SUBJECT: NuScale Power, LLC Submittal of the Approved Version of NuScale Topical Report, "Building Design and Analysis Methodology for Safety-Related Structures," TR-0920-71621, Revision 1

“Building Design and Analysis Methodology for Safety-Related Structures,” TR-0920-71621-P-A, Revision 1, proprietary version

RAI No.: 9833

Figure 8-9 Section cuts for one-way and two-way shear in basemat subject to wall overturning
~~Section cuts for out of plane shear (red) and bending (blue) in basemat subject to wall overturning~~

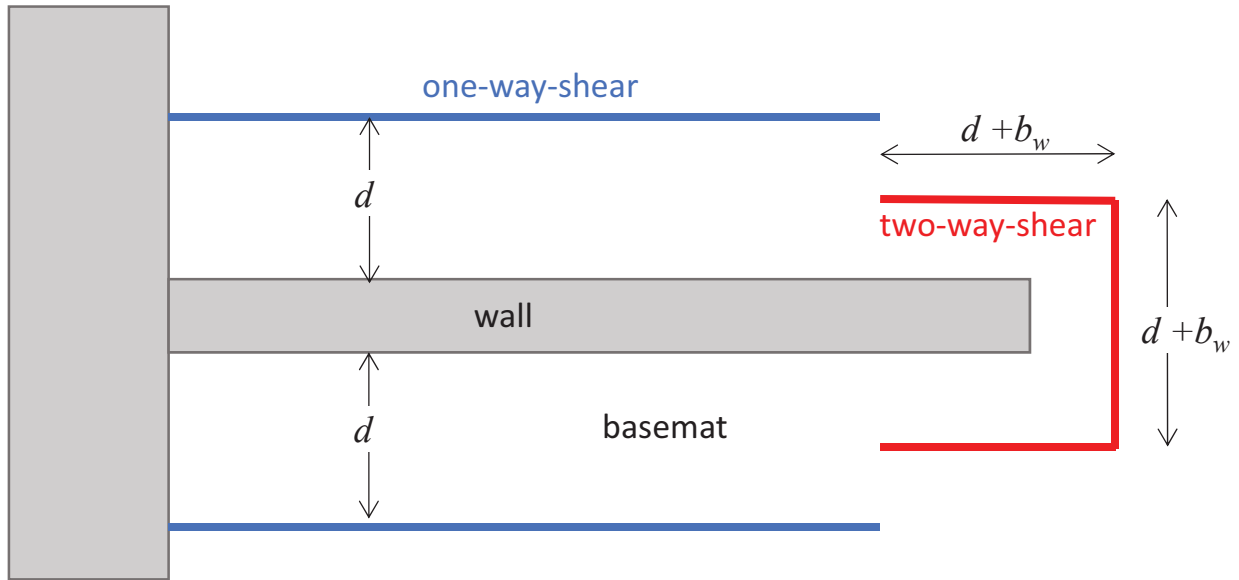
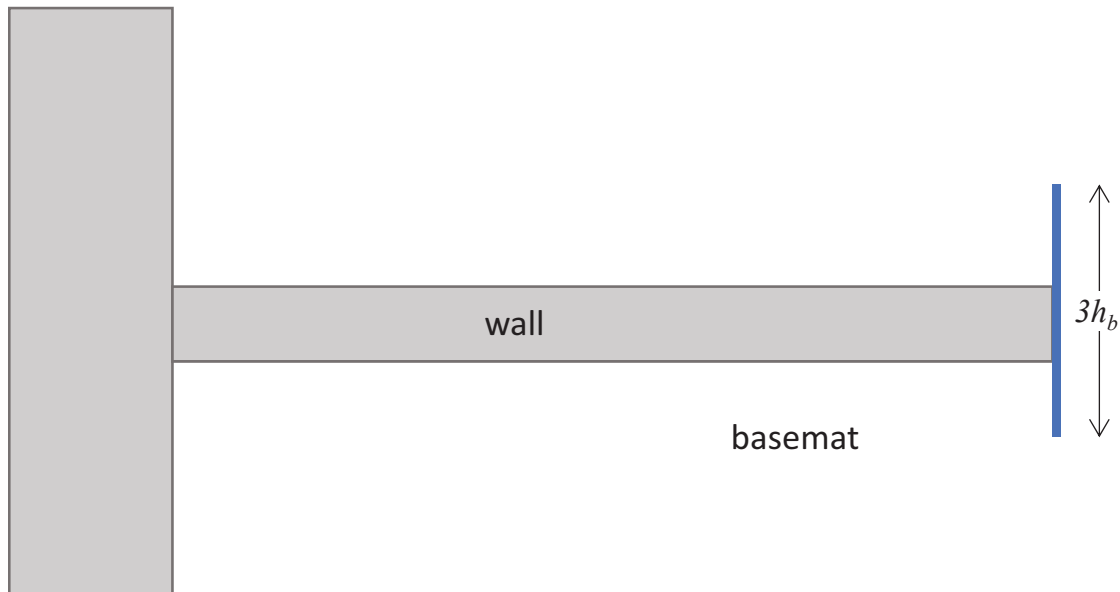
2. In Figure 8-10, "Section cut for two-way shear in basemat subject to wall overturning," of the TR, the applicant depicted the square section cut, in red, with a distance of "d+b_w," at each side at the end of continuous wall. In Section 8.5.1, "Section Cuts for Out-of-Plane Forces," the applicant also stated, *"if the out-of-plane shear demand calculated at these section cuts exceeds the basemat capacity corresponding to one-way or beam shear, then the failure mode would change to two-way or punching shear. In this situation, the shear capacity associated with this failure mode is instead considered and the associated demands are calculated at the section cut shown in red in Figure 8-10."*

~~The SC wall connection to the basemat is designed to sustain 125 percent of the SC wall tensile capacity. The tension demand in the SC walls translate to out of plane shear in the basemat. For this reason, the out of plane shear demand obtained at the section cut defined in Figure 8-9 is increased by 25 percent to account for the overstrength and to ensure ductile behavior in the SC wall basemat connection.~~

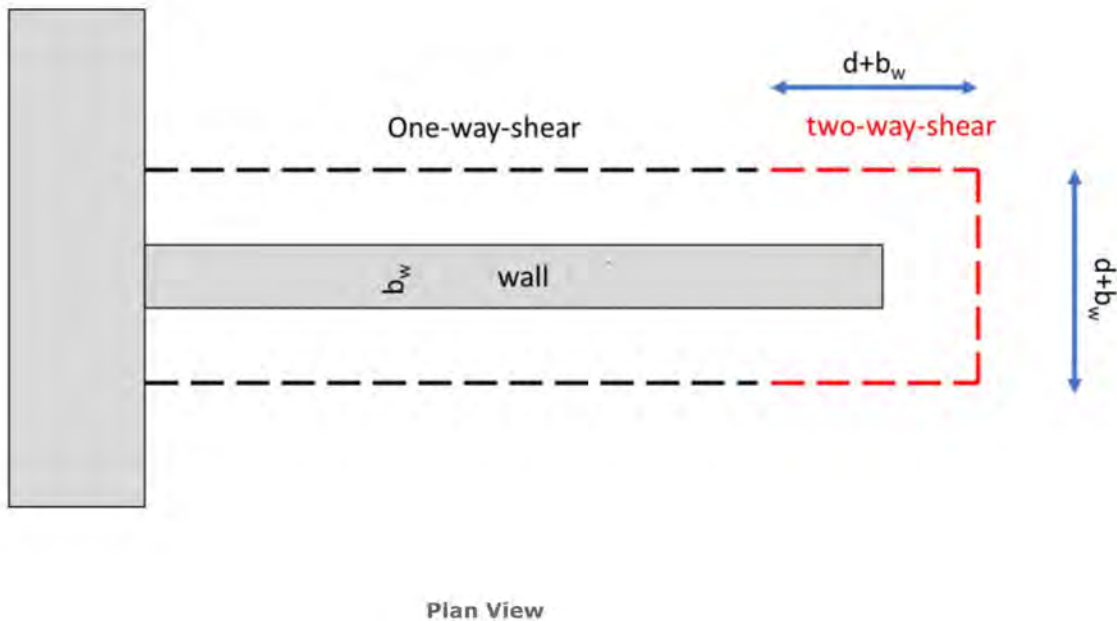
However, it is not clear to the staff the source for the change of the failure mode of section

cuts from one-way shear to two-way shear (punching shear), when the out-of-plane shear demand at these section cuts exceeds the basemat capacity corresponding to one-way shear. As shown below, it would be more correct to consider, both one-way shear and two-way shear, to get more accurate shear distribution around the shear perimeter of a slender blade-column in a foundation.

Topical Report TR-0920-71621, Building Design and Analysis Methodology for Safety-Related Structures, has been revised as described in the response above and as shown in the markup provided in this response.
